Staff Report
City of Richmond, Virginia

Commission of Architectural Review

9. COA-109613-2022	Final Review	Meeting Date: 4/26/2022
Applicant/Petitioner	Jennifer Radakovic	
Project Description	Enclose a rear, screened-in porch and replace a wooden railing with metal.	
Project Location		
Address: 405 N. Allen Ave.		
Historic District: Monument Avenue		
High-Level Details:		
<ul style="list-style-type: none"> The Applicant request permission to make alterations to the rear of a brick, colonial revival dwelling constructed circa 1908 The Applicant proposes to enclose a rear porch, and relocate an existing window from the rear, to the side elevation of the proposed enclosure. A portion of the rear privacy fence will be removed, and the rear wooden railing is proposed to be replaced with metal. Staff notes that the work being proposed is minimally visible from the public right-of-way. 		
Staff Recommendation	Approval, with Conditions	
Staff Contact	Alex Dandridge, alex.dandridge@rva.gov , (804) 646-6569

Figure 3. 1924 Sanborn Map. 405 N. Allen

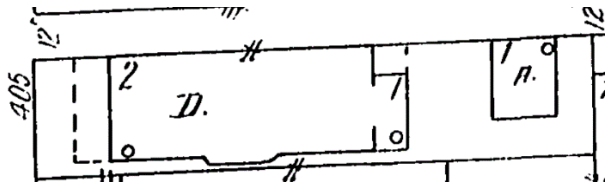
<p>Porches & Porch Details, pg. 49</p>	<p><i>New porch railing designs, compatible with the overall design of the building, will be considered.</i></p>	<p>The applicant proposed to replace an existing, wood railing on the rear porch with a new painted metal railing. On a site visit, Staff observed that the rear railing is not visible from the rear alley. Staff supportive of the installation of a more durable substitute material on the rear porch.</p>

Previous Reviews	None.	
Conditions for Approval	<ul style="list-style-type: none"> Staff recommends that the porch enclosure be clad in a horizontal siding with a differing width from the existing.
